Donald C. Cook Nuclear Plant Units 1
Compliance with March 12, 2012, NRC Order Regarding Mitigation Strategies for Beyond-
Design-Basis External Events (Order Number EA-12-049)

Enclosure 2 to AEP-NRC-2014-89

Enclosure 3 to AEP-NRC-2014-89

Responses to Items from the U. S. Nuclear Regulatory Commission (NRC) Interim Staff Evaluation, NRC Audit, and 3rd Overall Implementation Plan Update, Which Have Been Previously Addressed by Indiana Michigan Power Company and are Pending NRC Closure

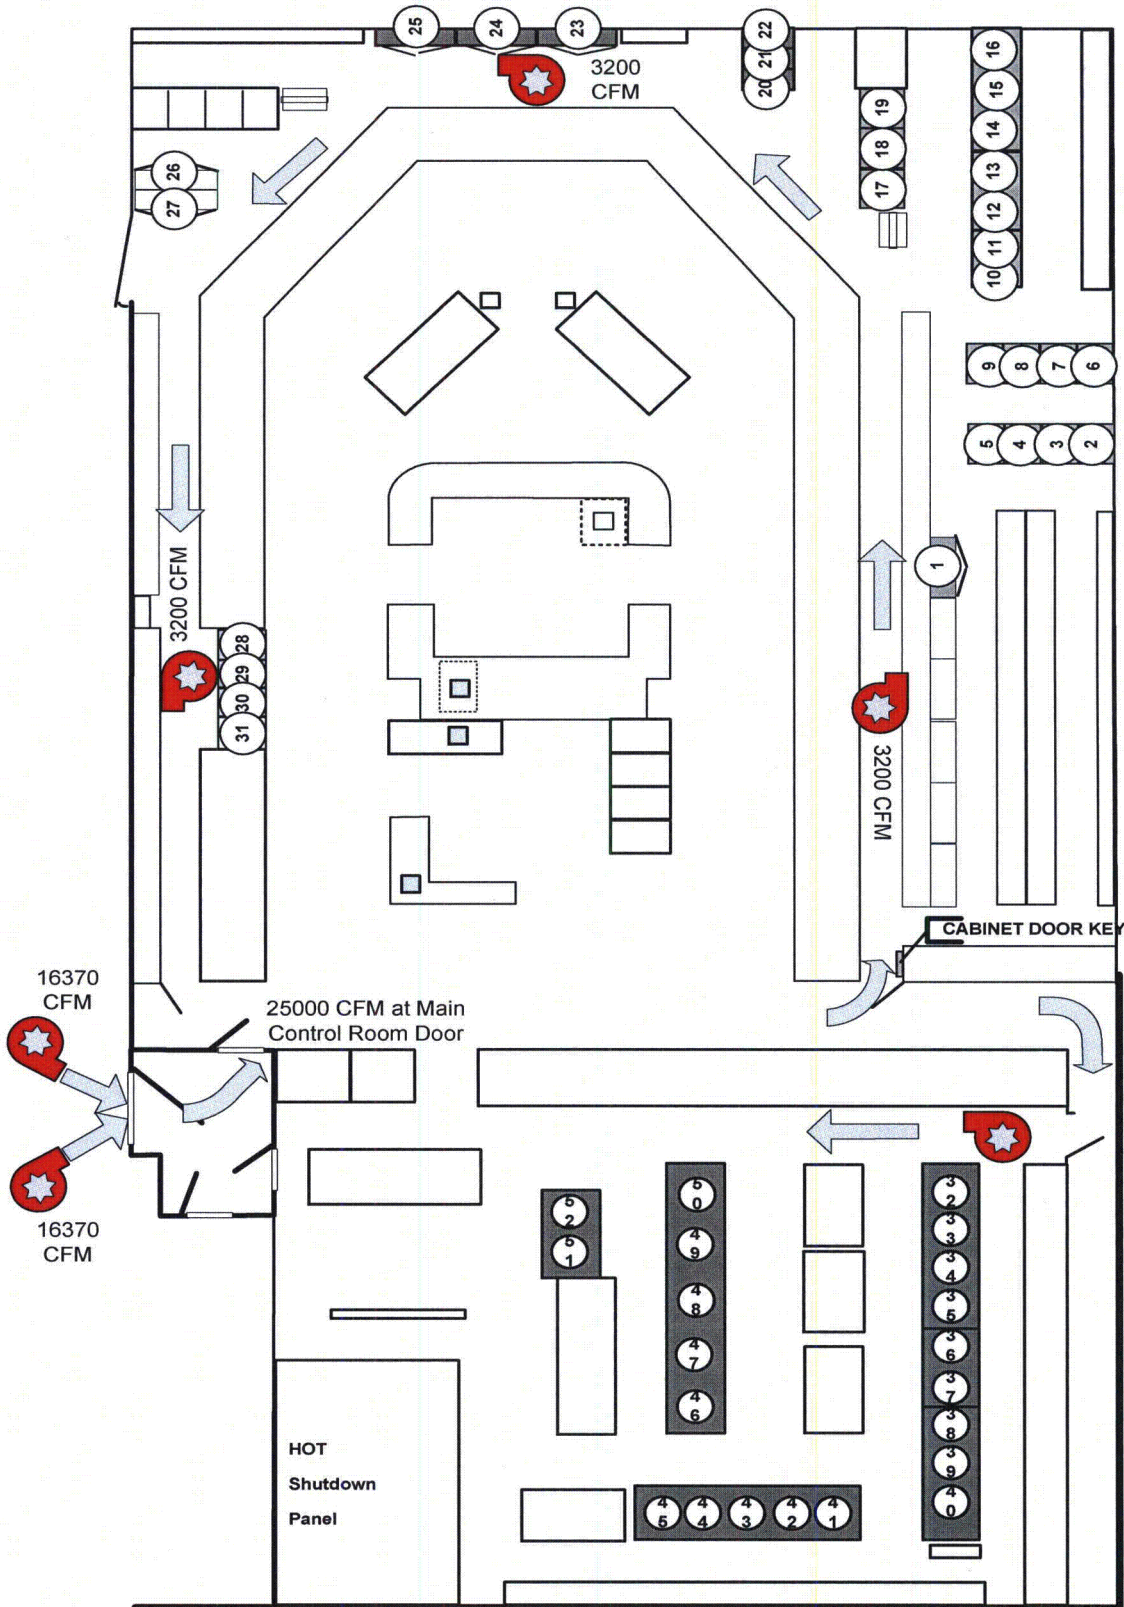
Audit Question (AQ)-36

Pages 48 and 50 of the integrated plan state that, "It may be desirable to open the Control Room complex doors ... " in different phases of an ELAP event; however, there are no time-sensitive actions specified in the integrated plan which support main Control Room habitability and/or equipment survivability.

Has a plant-specific, thermal hydraulic calculation been performed to determine what the maximum Control Room temperature would be based on the NEI 12-06 conditions? If so, please provide a summary of the calculation, the actions credited in it, and its results concluding that Control Room limits would be maintained in all phases of the ELAP event. If not, please provide the basis and justification for concluding that actions supporting main Control Room ventilation for habitability and/or equipment survivability will not be required on a time-sensitive basis during the course of an ELAP event.

Room Conditions for Personnel Habitability and Equipment Functionality - The licensee was still working on room analyses, which will result in some specific operator actions to be placed in FSG-5. The NRC will review the final analyses and procedural actions.

Room analyses for personnel habitability and equipment functionality.

Currently, CR instrumentation cabinet doors are opened as a 30 minute time-credited-action in the procedure for responding to loss of all AC power (1-OHP-4023-ECA-0.0). The applicable procedure step is designed to open the cabinet doors as soon as possible. Vital instrument cooling is assured if the cabinet doors are opened within 30 minutes from loss of all AC power. This action ensures adequate instrument cabinet cooling during the four-hour SBO response.

Since the postulated ELAP exceeds four hours, the evaluation described below was performed to determine what actions would be needed to provide adequate CR ventilation during the FLEX Phase 1 and Phase 2 response. Based the evaluation, the FSG for FLEX equipment staging (1-OHP-4027-FSG-501) directs installation of temporary fans similar to the fire protection program based response for loss of CR ventilation. The attached sketch shows the approximate fan locations.

The acceptability of this action was determined by qualitatively extrapolating the results of the calculation for CR temperatures during a postulated fire event. This calculation used a GOTHIC model and showed a nominal 117°F maximum resultant CR temperature with a similar temporary fan flow rate. The GOTHIC time transient model served to verify that adequate time existed to install and energize the temporary fans. The following simplified steady state computation validates that the CR temperature of 117°F is reasonable given a 104°F turbine building temperature.

$$\Delta T = Q / (\text{cfm} \times 1.08)$$

$$333,000 \text{ btu/hr} / (23943 \times 1.08) = 12.8^\circ\text{F}.$$

From other calculations, the SBO bounding heat load in the CR is 125,343 British Thermal Unit (btu)/ hour (hr), which is much less than the 330,000 btu/hr assumed in the calculation for CR temperatures during a postulated fire event. This SBO heat load reflects equipment powered by the station batteries and is a conservative representation for longer term loss of power events. With this reduced heat load the temperature rise over the temperature of the Turbine Building in which the CR is located is less than 5°F. Therefore, even considering elevated outside temperatures up to 110°F and a corresponding Turbine Building temperature (without heat loads), the CR temperature would remain bounded by the 117°F previously evaluated in the calculation for CR temperatures during a postulated fire event.
